PCI-SIG ENGINEERING CHANGE NOTICE

| TITLE: | Function Level Reset (FLR) |
| AFFECTED DOCUMENT: | PCI Express Base Specification, Rev. 1.1 |

Figure 7-12: Device Capabilities Register

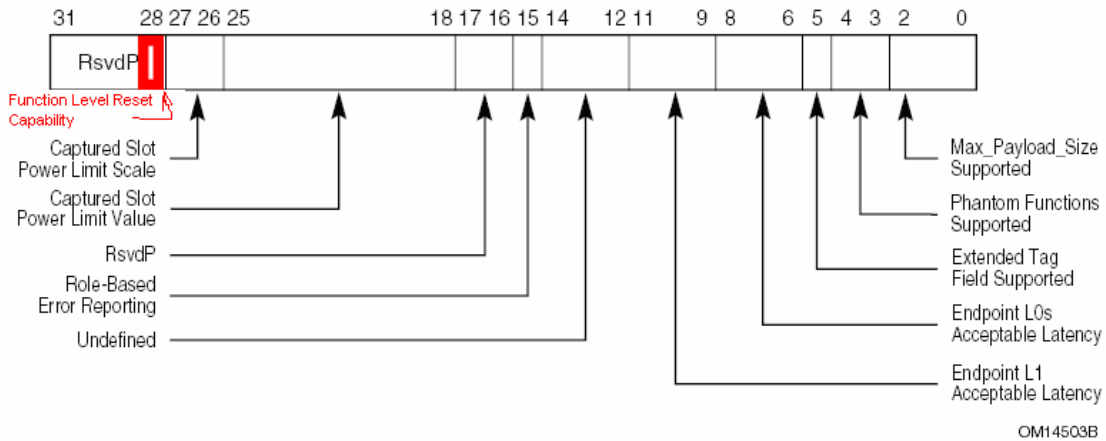
Change Section 7.8.3 Device Capabilities Register as follows:

| Bit Location | Register Description | Attributes |
|--------------|---|------------|
| <u>28</u> | Function Level Reset Capability – A value of 1b indicates the Function supports the optional Function Level Reset mechanism described in Section 6.6.2. <u>This field applies to Endpoints only. For all other device types this bit must be hardwired to 0b.</u> | <u>RO</u> |

Figure 7-13: Device Control Register

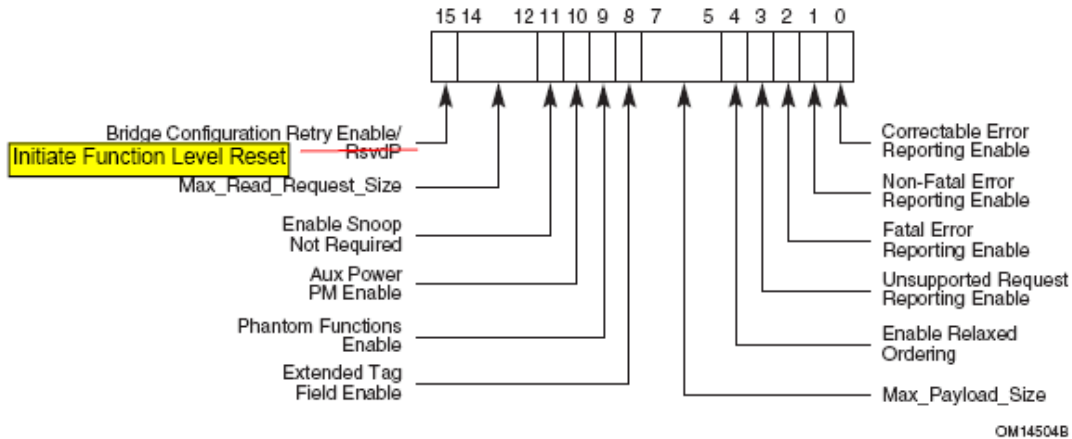
Change Section 7.8.4 Device Control Register as follows:

| Bit Location | Register Description | Attributes |
|--------------|---|---|
| 15 | <p><i>PCI Express to PCI/PCI-X Bridges:</i> Bridge Configuration Retry Enable – When set, this bit enables PCI Express to PCI/PCI-X bridges to return Configuration Request Retry Status (CRS) in response to Configuration Requests that target devices below the bridge. Refer to the <i>PCI Express to PCI/PCI-X Bridge Specification, Rev. 1.0</i> for further details. Default value of this field is 0b.</p> <p><u>Endpoints with Function Level Reset Capability set to 1b:</u> Initiate Function Level Reset – A write of 1b initiates Function Level Reset to the Function. The value read by software from this bit is always 0b.</p> <p>All others: Reserved – Must hardwire the field to 0b.</p> | <p>PCI Express to PCI/PCI-X Bridges: RW</p> <p><u>FLR Capable Endpoints:</u> RW</p> <p>All others: RsvdP</p> |
